UNITED STATES PATENT AND TRADEMARK OFFICE

10/697,027

Office Action Summary	Application No. 10/697,027	Applicant(s) OKADA, KAZUO	
	Examiner RYAN HSU	Art Unit 3716

DETAILED ACTION

FIG. 1

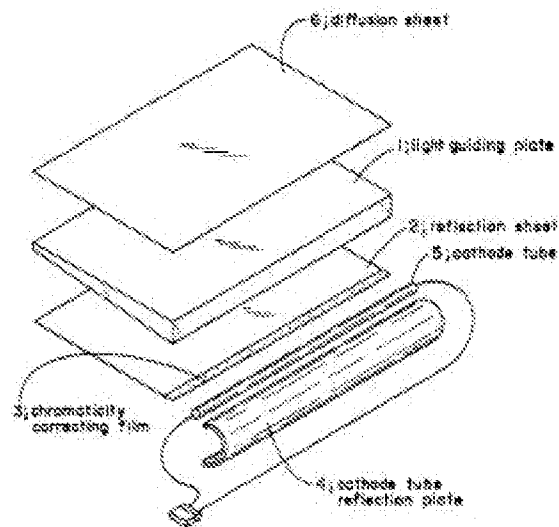
2. Applicant claims that Muir is a rigid display layering set up and therefore does not allow for change and modifications. In this circumstance the implementation of a diffusion sheet or light guiding plate is not a change or modification of the Muir reference. These elements are basic elements of the disclosed LCD display device. The reasoning taken by the applicant's representative by narrowing the scope of Muir's does not change the teachings provided by Ohta. Such a rationale is proper for an obviousness type rejection as it is to be viewed from a person of ordinary skill in the art. This stated level of ordinary skill is also a person of "ordinary creativity, not an automaton" (*see 2141.03 citing KSR v. Telflex* 82 USPQ 2d 1385, 1397 (2007)). The examiner now details the rationale for the rejection as follows: Muir discloses the use of a symbol display device behind an image display device. The image display device disclosed is an LCD display. The prior art of Ohta, teaches that an LCD display comprises a back light device and an LCD panel. The LCD display unit is further made up of the following elements, a diffusion sheet (6), a light guiding plate (1), a reflection sheet (2), and a cathode tube (5) that provides the light source for the display device as is details in the included figure 1.

4. It is through this teaching that shows how Muir's disclosed LCD display incorporates the claimed elements of a diffusion sheet and light guiding plate through the use of an LCD display. Therefore the claim limitations are simply a recitation of known elements performing functions encompassed by an LCD display to produce the expected result of presenting game elements onto an image display device.
